OUTLINE DEVELOPMENT PLAN (ODP) NO. 119 - LOTS 10, 11 & 14 TOODYAY ROAD, GIDGEGANNUP (CITY OF SWAN)

I refer to your correspondence dated 15 August 2008 regarding the final endorsement of Outline Development Plan No. 119. In this regard, the Western Australian Planning Commission (WAPC) has considered Outline Development Plan No. 119 relating to Lots 10, 11 and 14 Toodyay Road Gidgegannup and has resolved pursuant to clause 5A.1.1 and 5A.1.10.2 of the City of Swan Local Planning Scheme No. 17 to endorse Outline Development Plan No. 119 approved by the City of Swan on the 14 August 2008 as a basis for its decision making over the subject land subject to the following modification:

FINAL ENDORSEMENT OF OUTLINE DEVELOPMENT PLAN / STRUCTURE PLAN NO. 119 - LOT 10, 1408 TOODYAY ROAD, GIDGEGANNUP LOT 14, 1428 TOODYAY ROAD, GIDGEGANNUP LOT 11, 1448 TOODYAY ROAD, GIDGEGANNUP

RE: LOTS 10, 11 AND 14 TOODYAY ROAD CORNER OF ROLAND ROAD, GIDGEGANNUP PROPOSED OUTLINE DEVELOPMENT PLAN

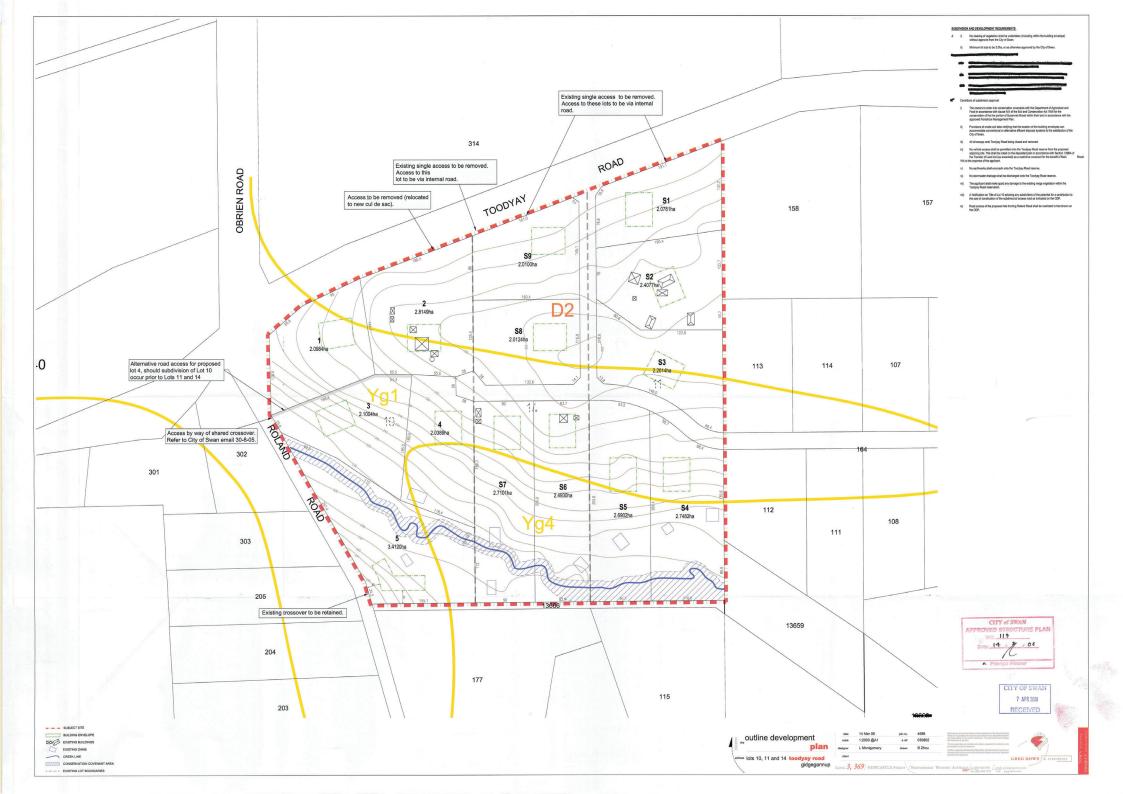
i) Reference to "Alternative road access for proposed lot 4, should subdivision of Lot 10 occur prior to Lots 11 and 14" and the depiction of this alternative access through to Roland Road on the plan being deleted.
